Item Name: Crosstube Turning Detail

DART AEROSPACE LTD	Work Order:	107542
Description: Crosstube Assembly (412 High Aft)	Part Number:	D412-664-243
Inspection Dwg: D412-664-243 Rev: E		Page 1 of 2

DRAWING NO. D412-664-243	TITLE CROSSTUBE ASS'Y (412 HI AFT)	REV. E	DART AEROSPACE LTD ENGINEERING ORDER		D.E.O. NO. D412-664-243-E-2	SHEET NO. SHEET 1 OF 1	SCALE NTS
DRAWN 97	CHECKED ASS	MFG. APPR. E	APPROVED MP		DE APPR. H		
DATE 11.09.07	DATE 11.09.19	DATE 11.09.19	DATE 11.09.19		DATE 11.09.19

DRAWING NO. D412-664-243	TITLE CROSSTUBE ASSEMBLY (412 HI AFT)	REV. E	DART AEROSPACE LTD ENGINEERING ORDER	D.E.O. NO. D412-664-243-E-4	SHEET NO. SHEET 1 OF 3	SCALE NTS
DRAWN <i>92</i>	CHECKED <i>A</i>	MFG. APPR. <i>A</i>	APPROVED <i>MD</i>	DE APPR. <i>MD</i>		
DATE 12.08.21	DATE 12.08.30	DATE 12.08.30	DATE 12/8/30	DATE 12.08.30

**D412-664-243
ASSEMBLY DETAIL**

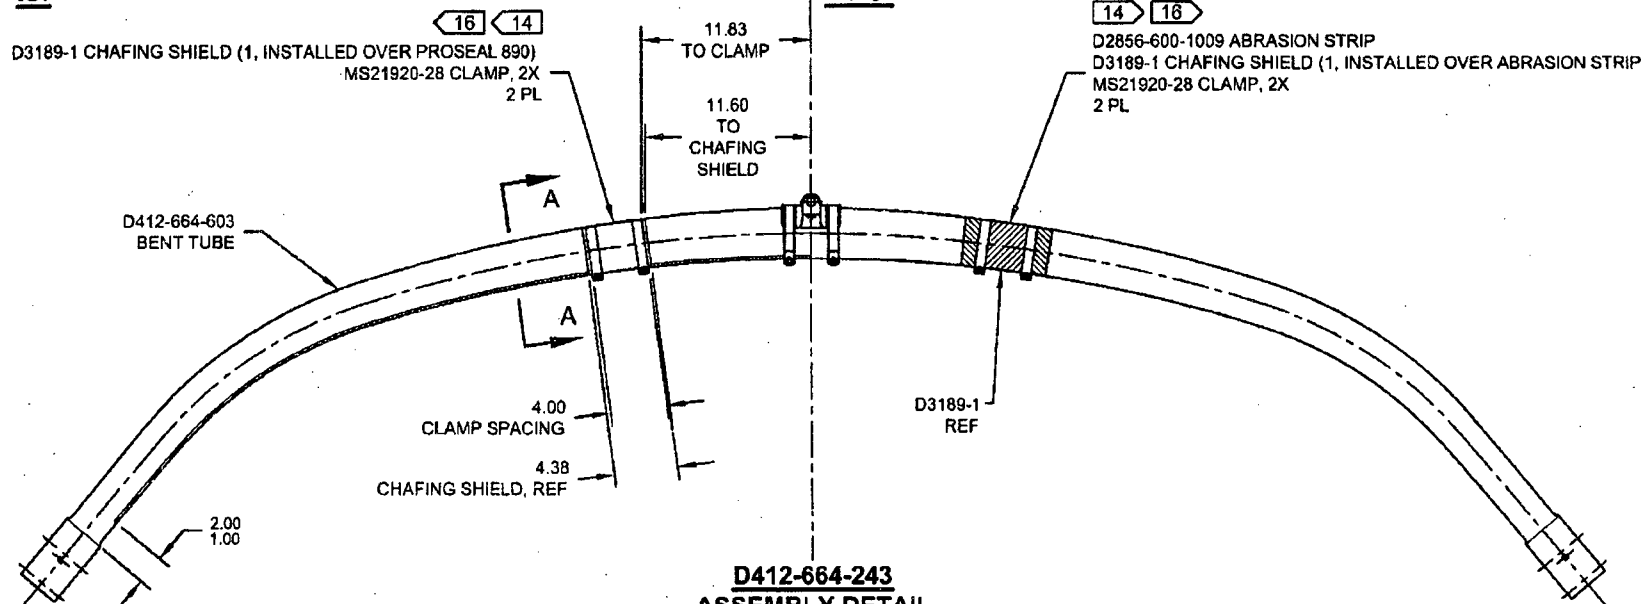
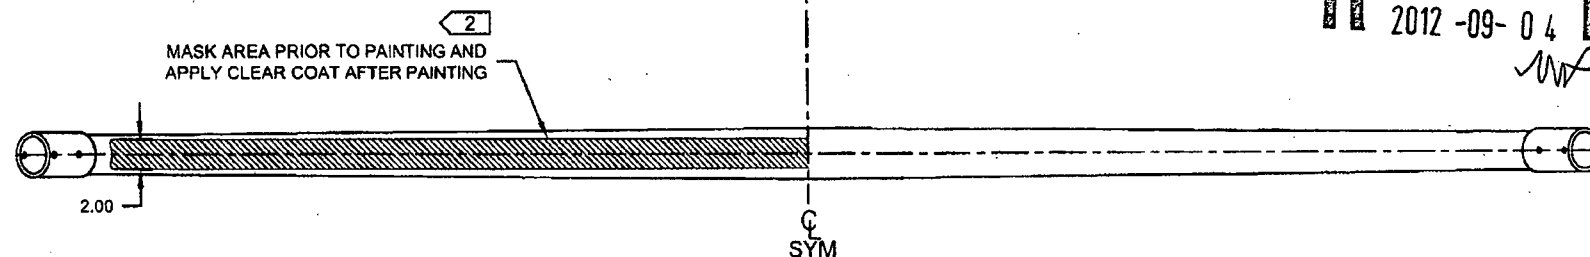
PURPOSE:

REMOVED ABRASION STRIP IN FAVOR OF A THIN LAYER OF PROSEAL 890. UPDATE INSTALLATION OF CHAFING SHIELDS AND REDUCE TORQUE TO 40-50 IN-LBS. THIS ENGINEERING ORDER SUPERCEDES DEO D412-664-243-E-1.

IS:

D3189-1 CHAFING SHIELD (1, INSTALLED OVER PROSEAL 890)
MS21920-28 CLAMP, 2X
2 PL

WAS:

D2856-600-1009 ABRASION STRIP
D3189-1 CHAFING SHIELD (1, INSTALLED OVER ABRASION STRIP)
MS21920-28 CLAMP, 2X
2 PL
